RE: **Apartment Urban Living @ Nob Hill
Central and Montclair NE
Conceptual Grading Plan Stamp Date: 10/29/18
Drainage Report Stamp Date: 10/29/18
Hydrology File: K17D073**

RE: Apartment Urban Living @ Nob Hill (K17D073)

Supplemental Drainage Calculations

Apartment Urban Living @ Nob Hill

First flush volume retained within storm drain pipe system

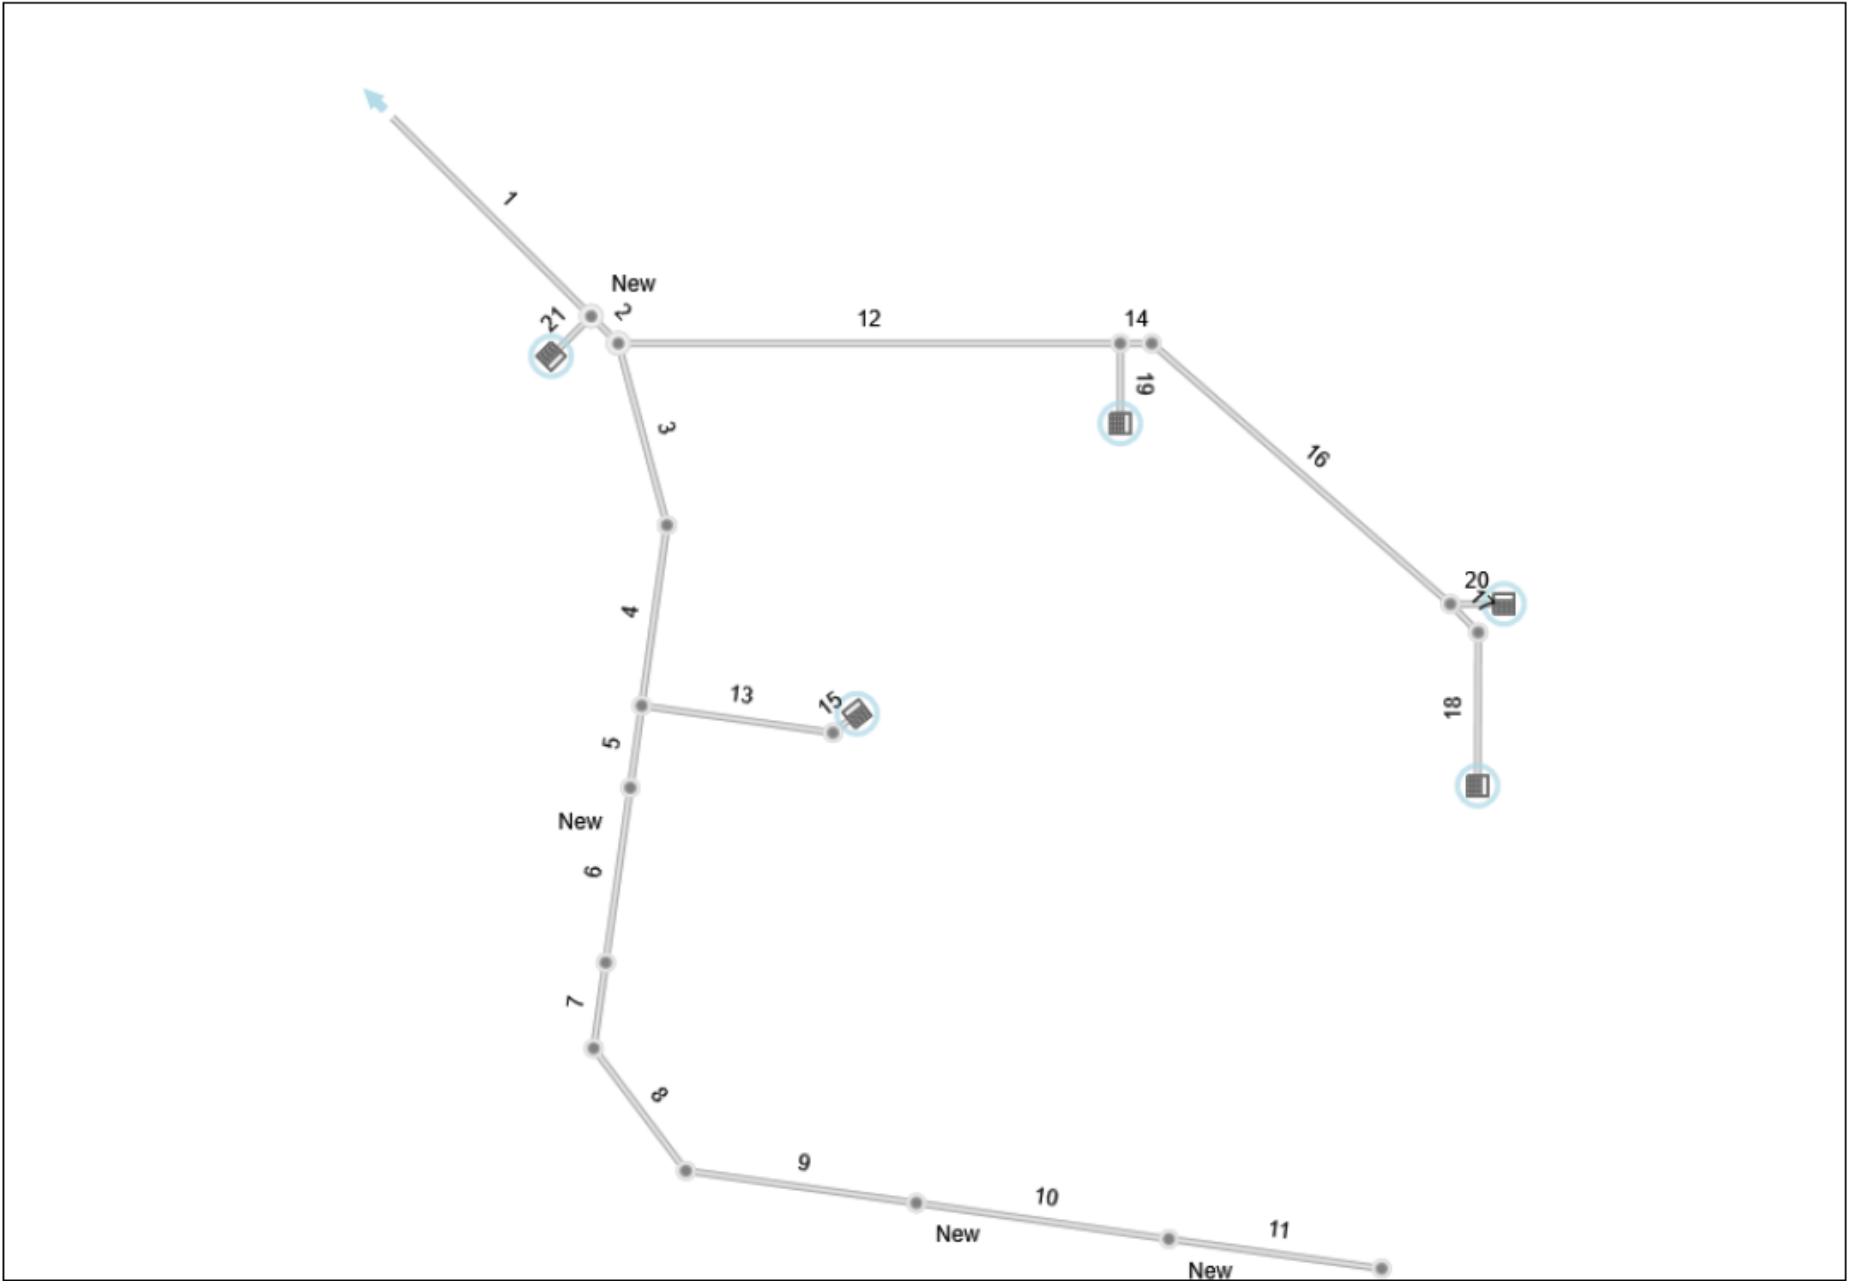
1. Storm water quality (SWQ) volume credit cannot be allowed for the volume stored in the pipes, unless those pipes are perforated and surrounded in gravel bedding for their respective lengths (a French drain). If you add gravel bedding, you can take credit for this pipe volume, plus the volume contained in the gravel voids using a porosity of 30% ($e=0.30$). Otherwise fee-in-lieu of the SWQ volume is required for the full amount of impervious area: ~83292sf.

The proposed storm drain system with bubble-up outlet will retain a volume of 304 cf within the portion of the system below the bubble-up rim elevation (see following sheet for calculations). Due to a lack of available landscape area, the owner requests to provide payment-in-lieu for the remaining 1,501 cf.

Energy Grade Line Calculations*

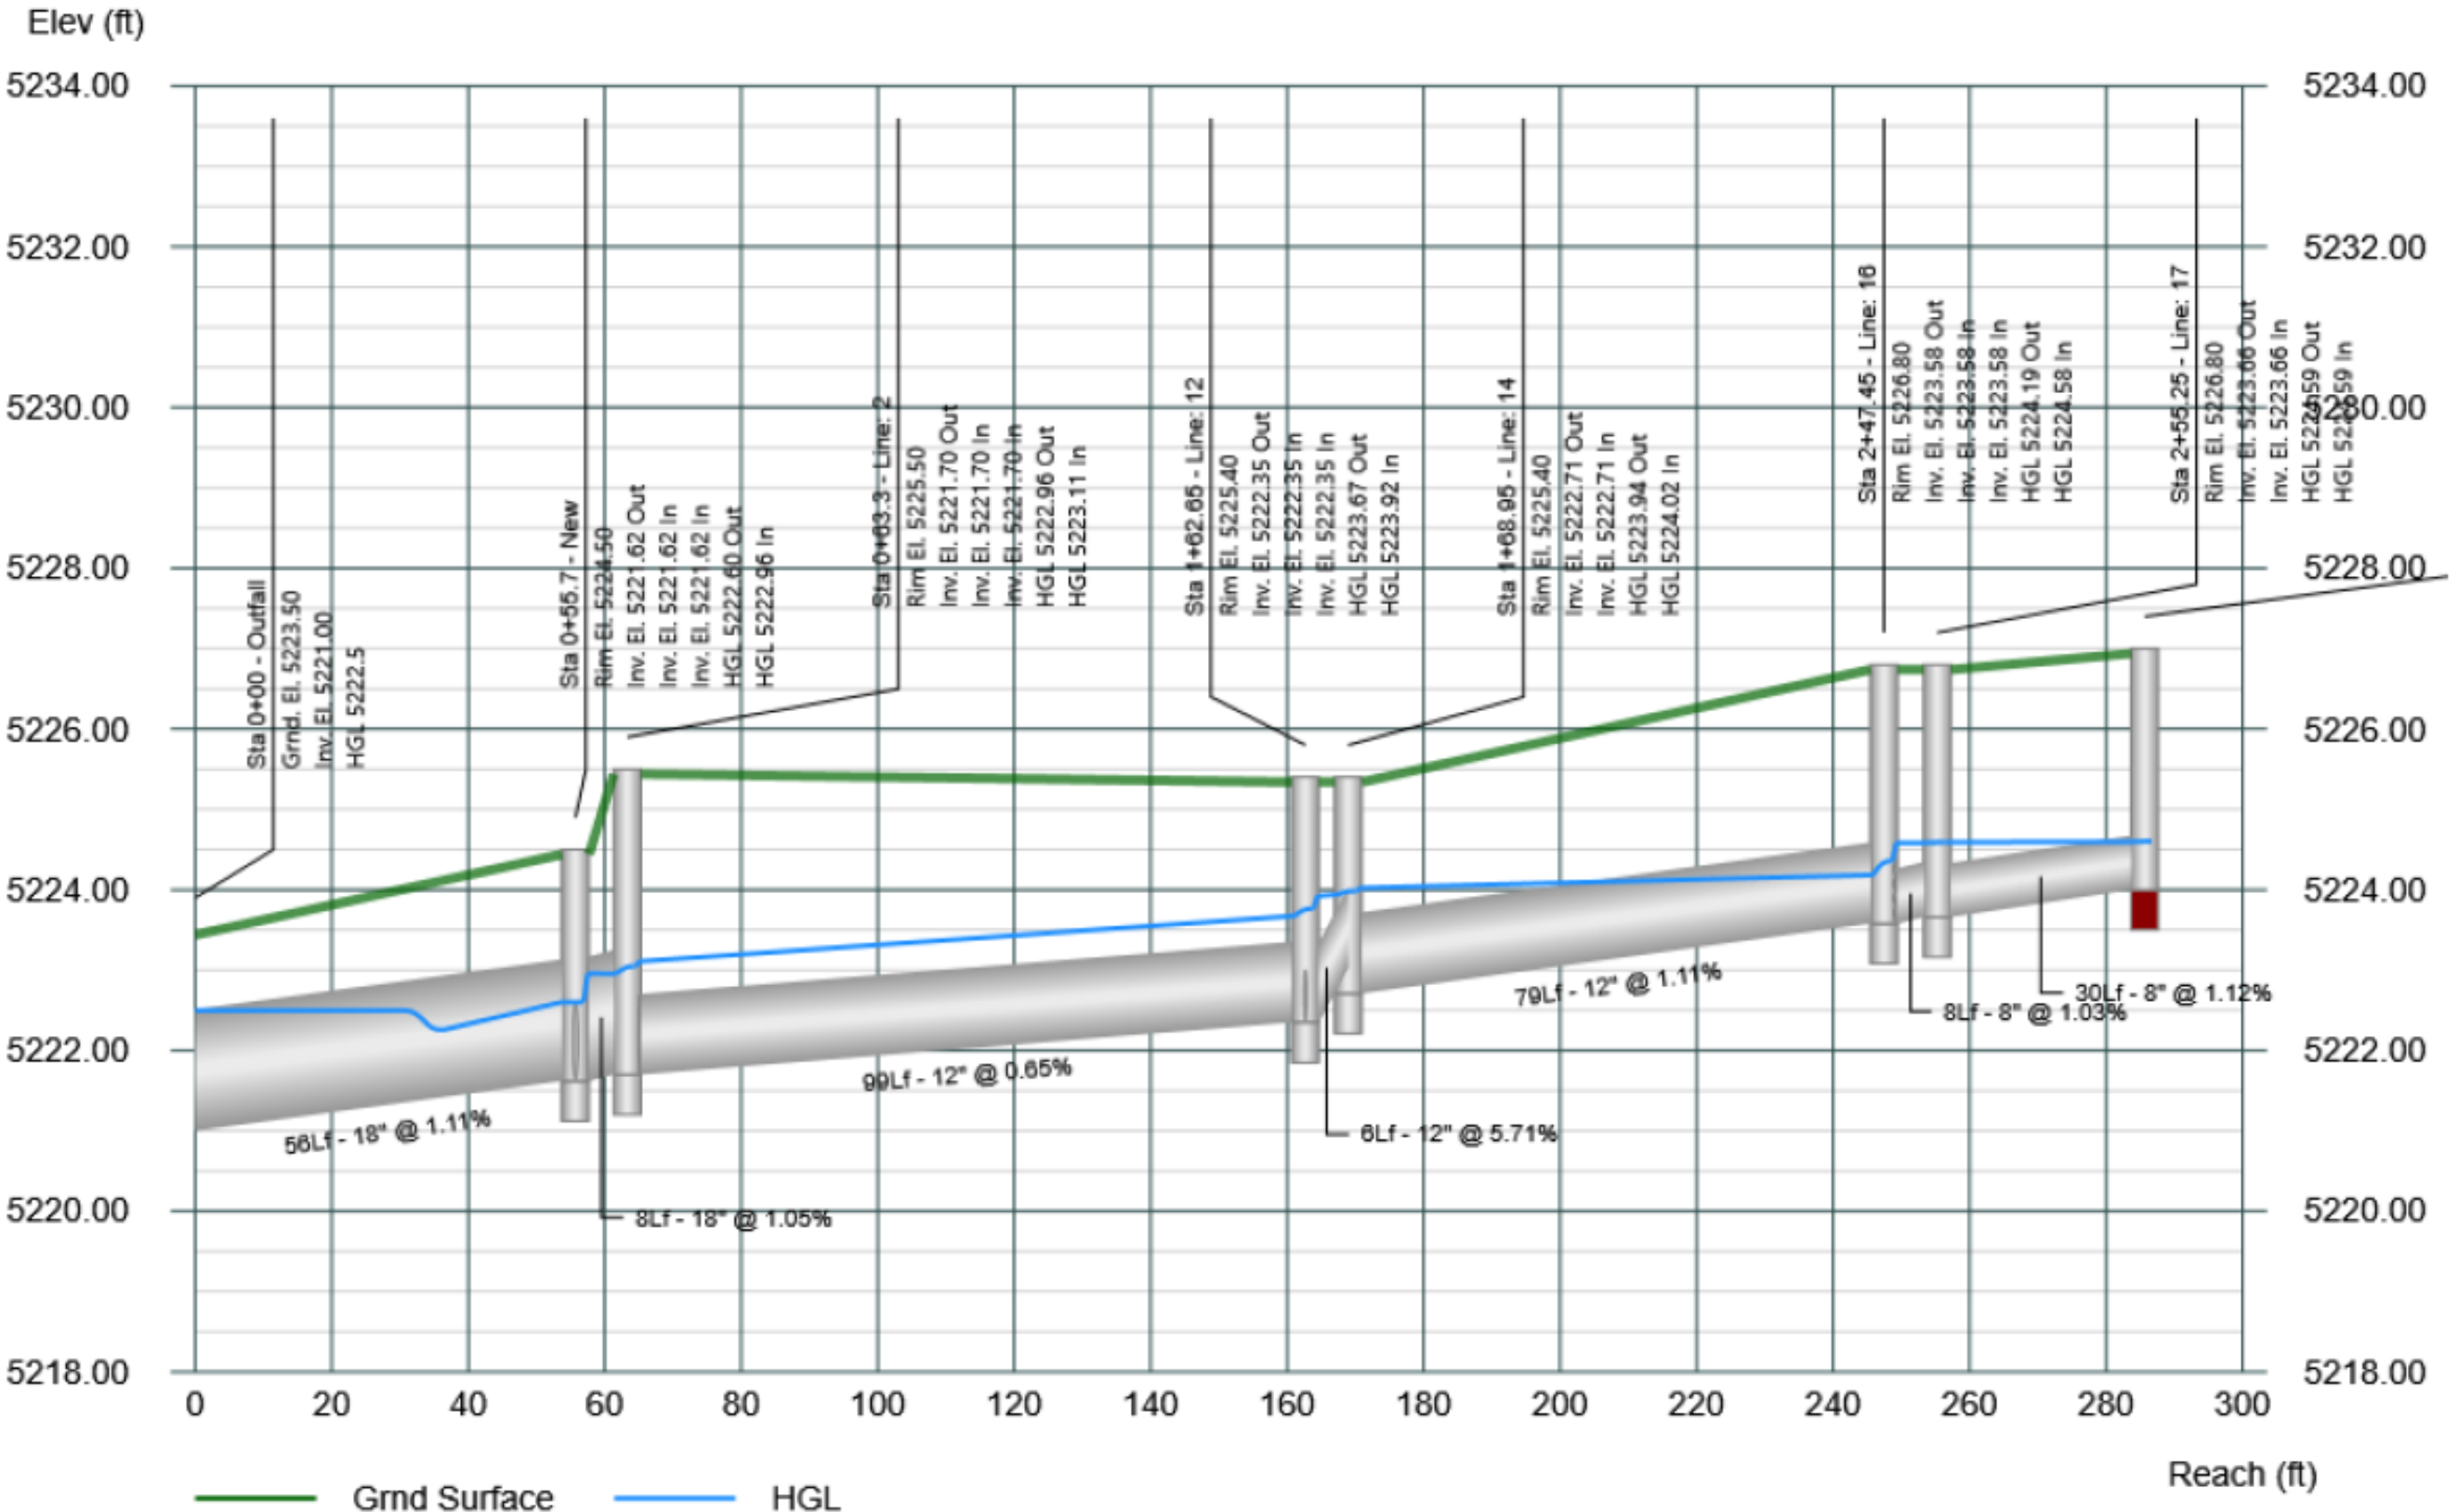
- d. The HGL output table provided did not have any of the results.
10. This project requires an ESC Plan, submitted to the Stormwater Quality Engineer (Curtis Cherne PE, ccherne@cabq.gov or 924-3420).

GRADING AND DRAINAGE PLAN

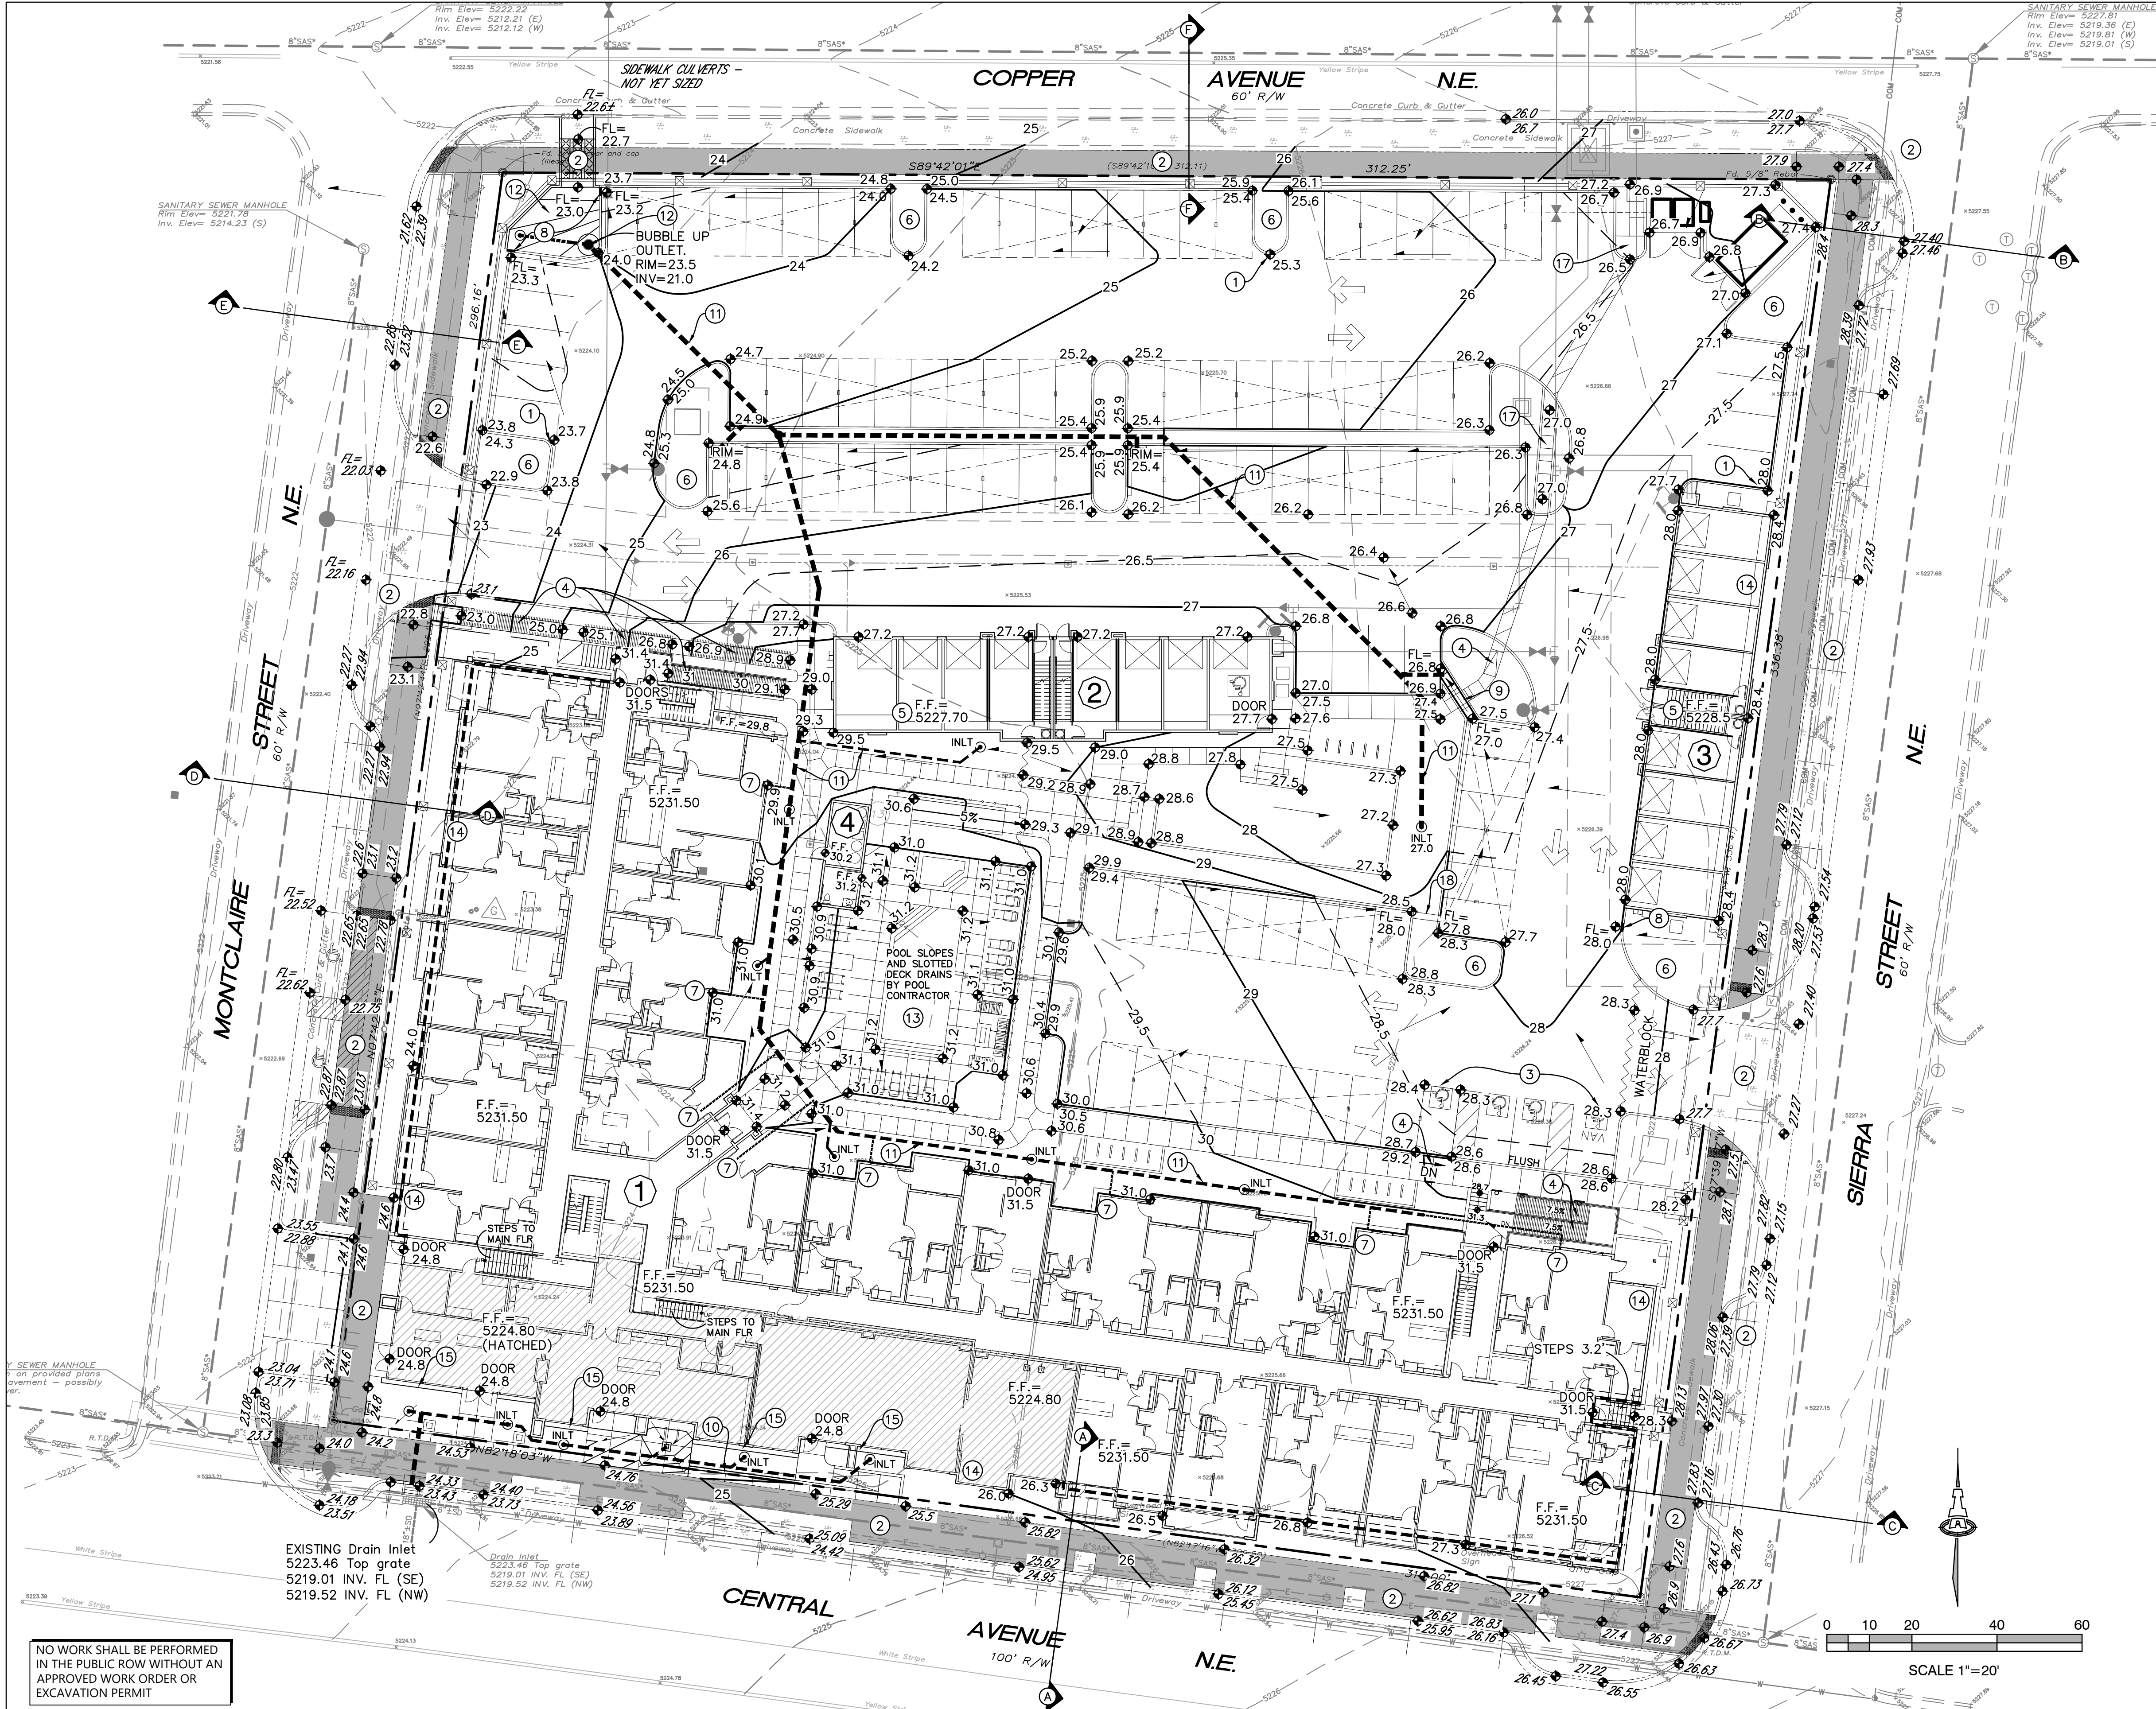
3. After reviewing the proposed channel on Copper in greater detail, we cannot allow in to be placed in the ROW; revise the plan and infrastructure list to just extend the sidewalk culverts out to the face-of-curb on Copper.

- b. Pond rating curve and routing of the 100-yr event. Also show the 100-yr water surface on the grading plan.
 - c. The HGL calculations need to use the maximum water surface elevation above the bubble-up grate as the downstream starting EGL.
